MIL-T-60500A(MU)
AMENDMENT 6
15 January 1973

MILITARY SPECIFICATION

TRANSCEIVER: 10540501

This amendment forms a part of Military Specification MIL-T-60500A(MU), dated 22 September 1970.

FIGURE 3

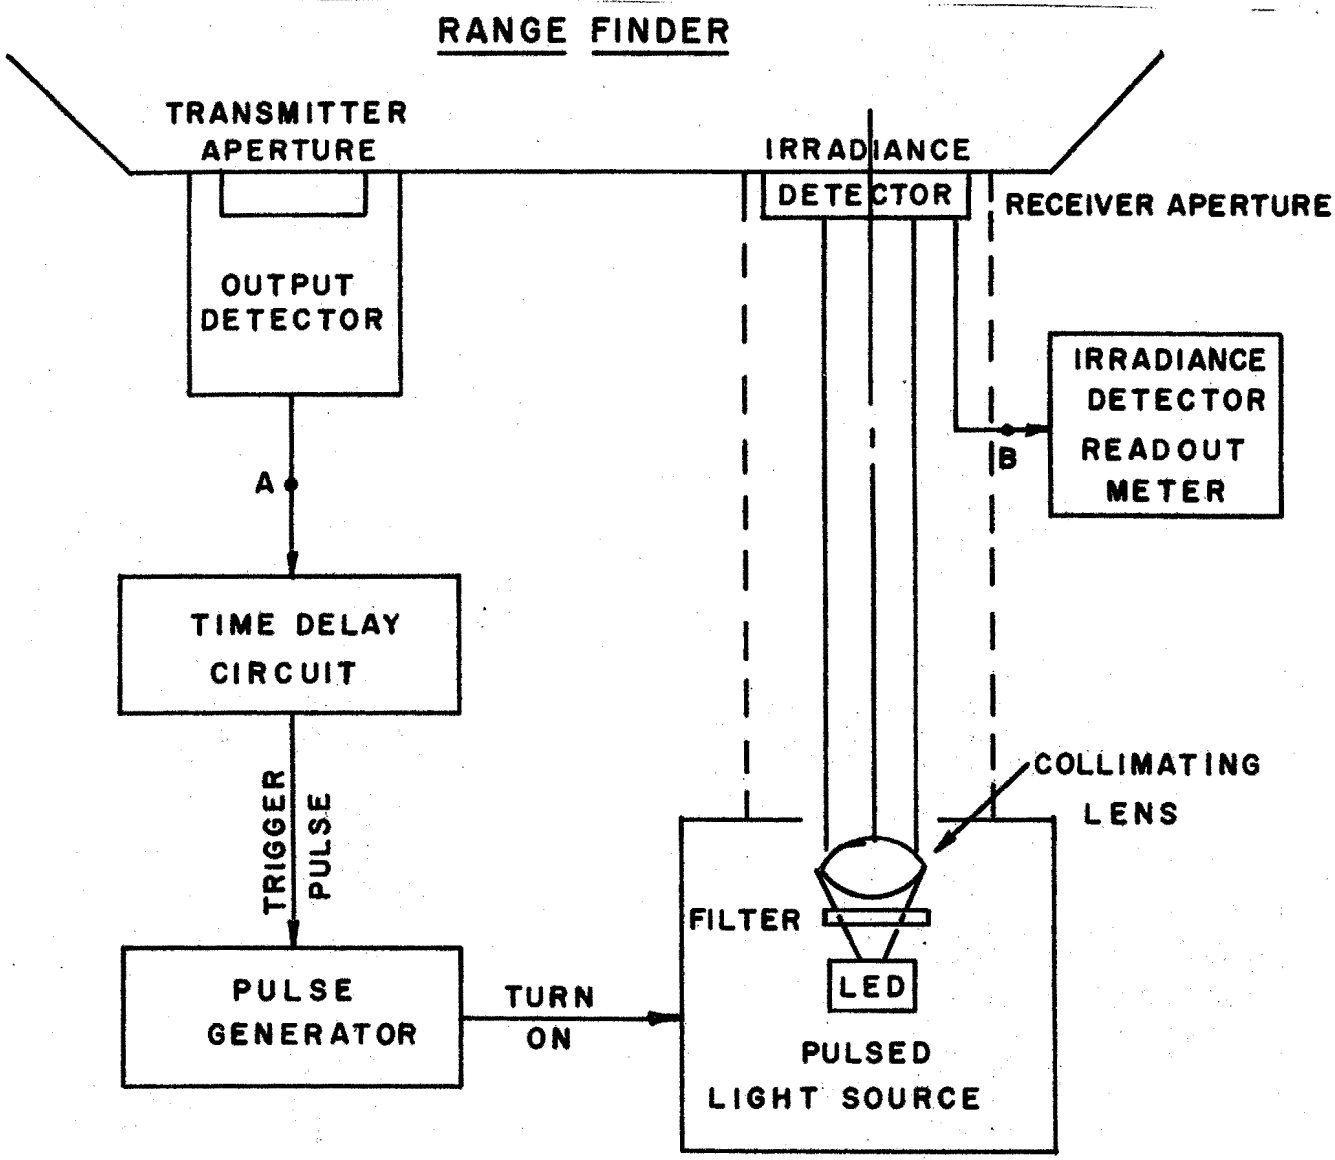
Figure 3: Delete and substitute attached Figure 3.

NOTE: 1. MEASURE TIME DELAY FROM POINT "A" FROM OUTPUT DETECTOR TO POINT "B" FROM IRRADIANCE DETECTOR.

2. ISOLATE THE RECEIVER APERTURE TO PREVENT ERRONEOUS READINGS FROM REFLECTIONS FROM OUTPUT PULSE.

RECEIVER SENSITIVITY TEST SETUP
